# Comment #77

## Review / Proposed Response

IEEE 802.3 NEW ETHERNET APPLICATIONS AD HOC  
FEB 24, 2020 TELECONFERENCE AD HOC MEETING

# Background – Figure 52 (D1.1)

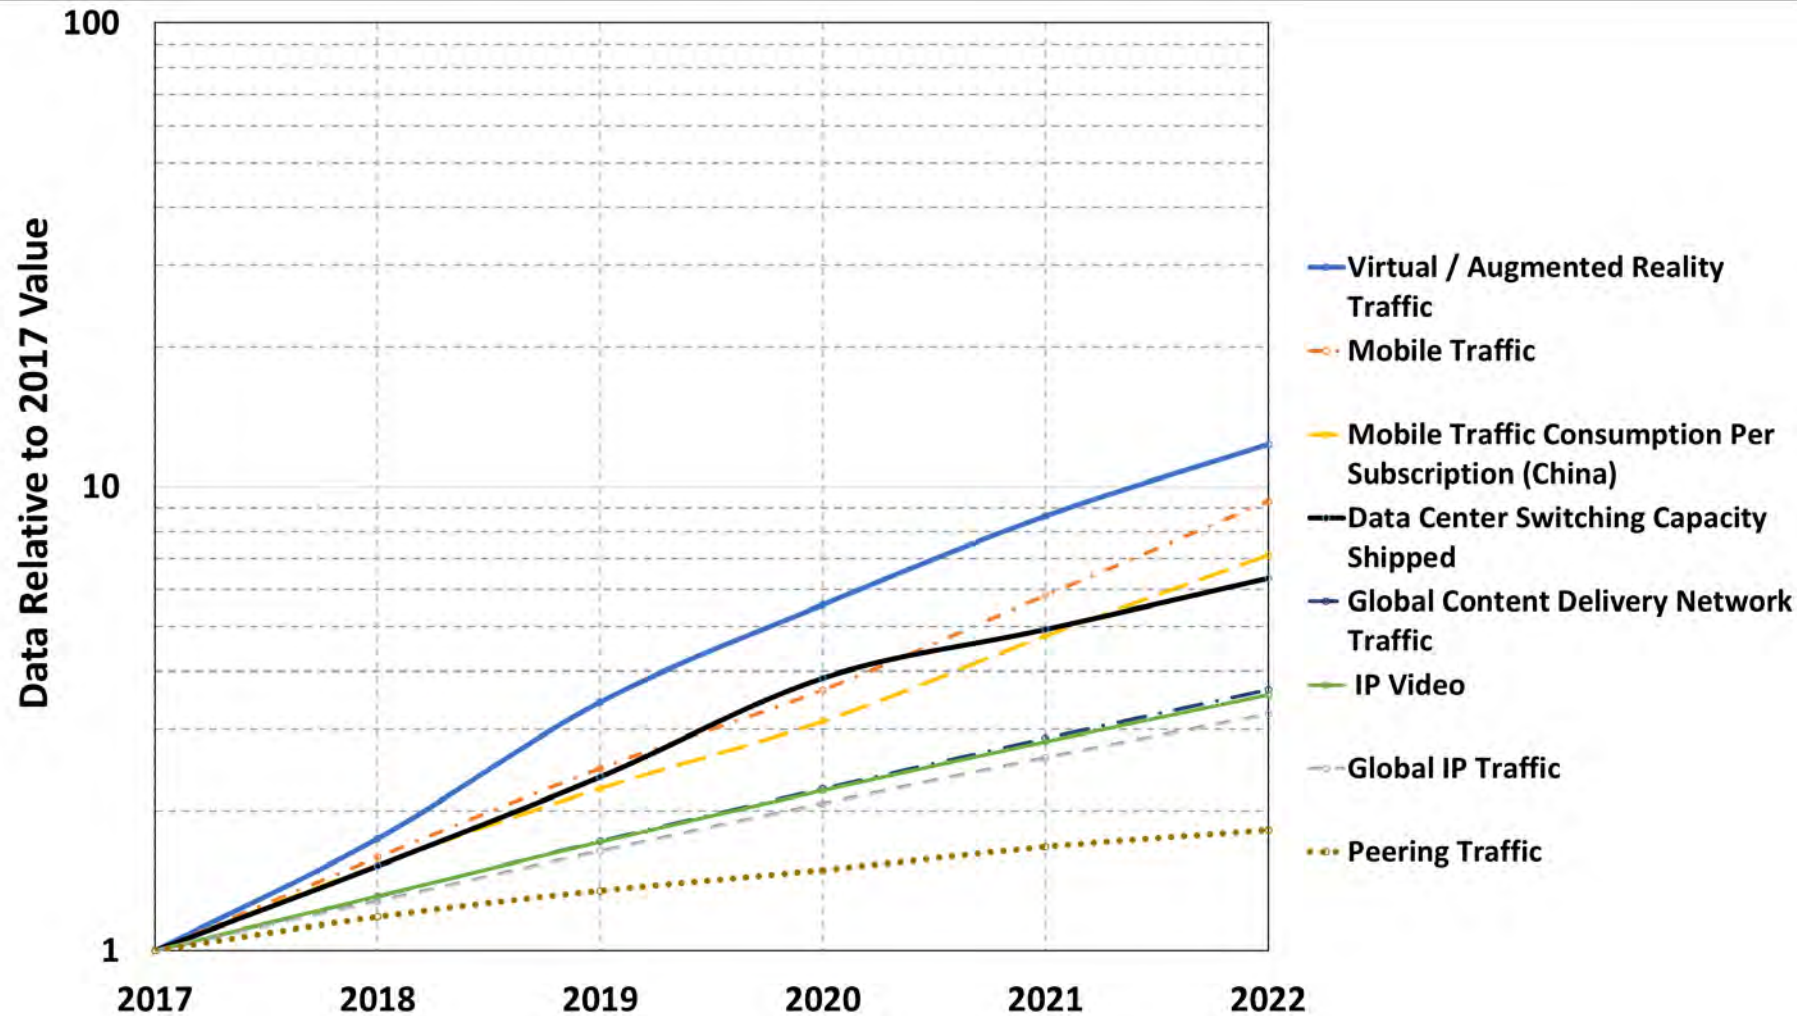
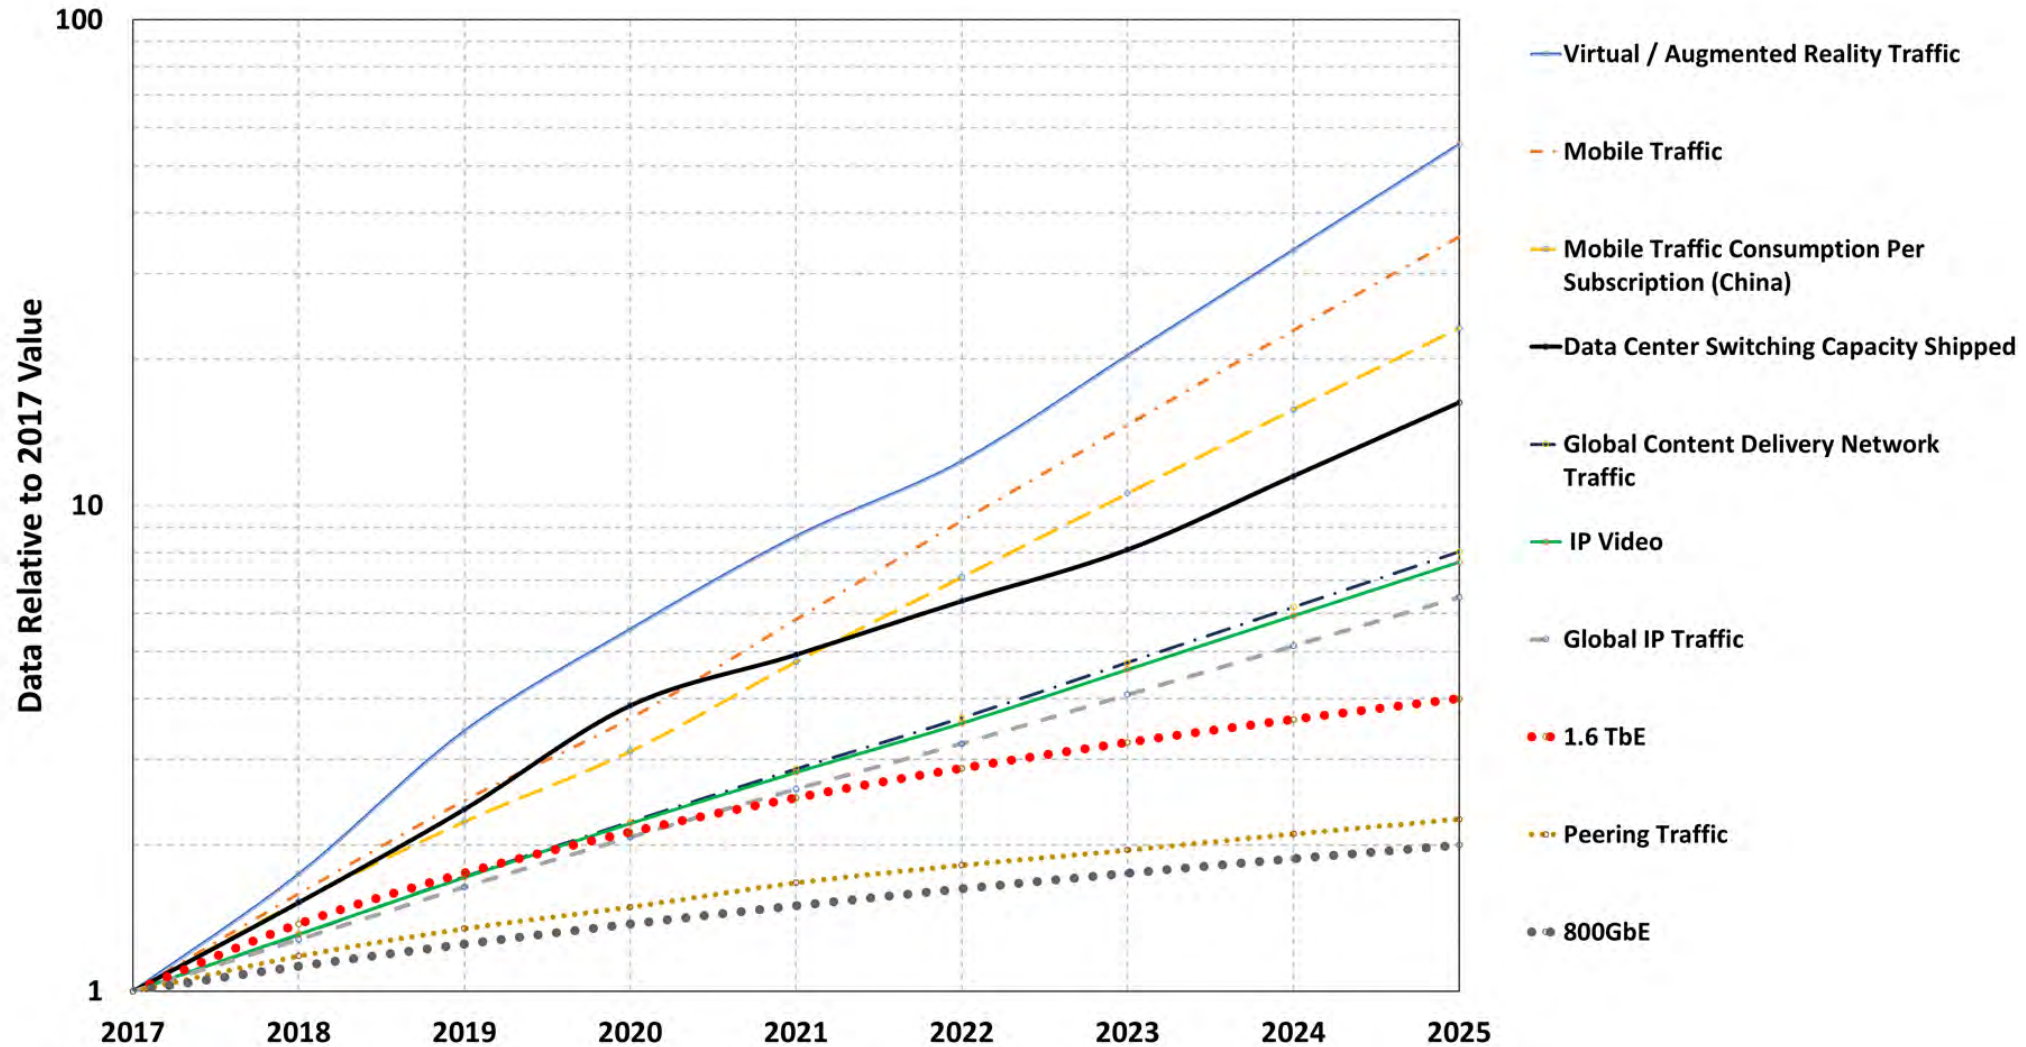
Comment #77 –

I don't see how the curves for 800GbE and 1.6GbE were generated. I would expect a straight line from the same point where 400 GbE was standardized.

Proposed Remedy –

Please provide a better explanation for the generation of these curves.

Proposal: Replace noted text from Slide #3 with the following.

Given the anticipated publication of this report in 2020, it was felt that a forecast 2 years beyond the publication date was insufficient, and a 5-year forecast would be more beneficial. To create the series of forecast curves shown in Figure 52, the following steps were taken:

- The forecast for "Global IP Traffic", "IP Video", "Virtual/ Augmented Reality Traffic", and "Global Content Delivery Network Traffic" were extended to 2023 - 2025 based on the reported CAGR for each parameter.
- The forecast for "Peering Traffic" was extended to 2023-2025 based on an exponential fit of provided data.
- The forecast for "Data Center Switching Capacity Shipped" was extended for 2024-2025, based on the calculated CAGR of the provided data for 2017-2023)

Two possible futures for Ethernet beyond 400 Gb/s are commonly discussed: **800 Gb/s Ethernet and 1.6 Tb/s Ethernet.** Based on prior experience, a project to develop either data rate would take 5 years and would complete in 2025 if started in 2020. Normalizing 400 Gb/s to the year it was standardized (2017), 800 Gb/s is noted as a 2x increase over 400 Gb/s in 2025, and 1.6 Tb/s is noted as a 4x increase over 400 Gb/s in 2025. To enable a comparison to the noted forecast curves, dashed lines were added between the introduction of 400 Gb/s in 2017 and each new data rate in 2025.
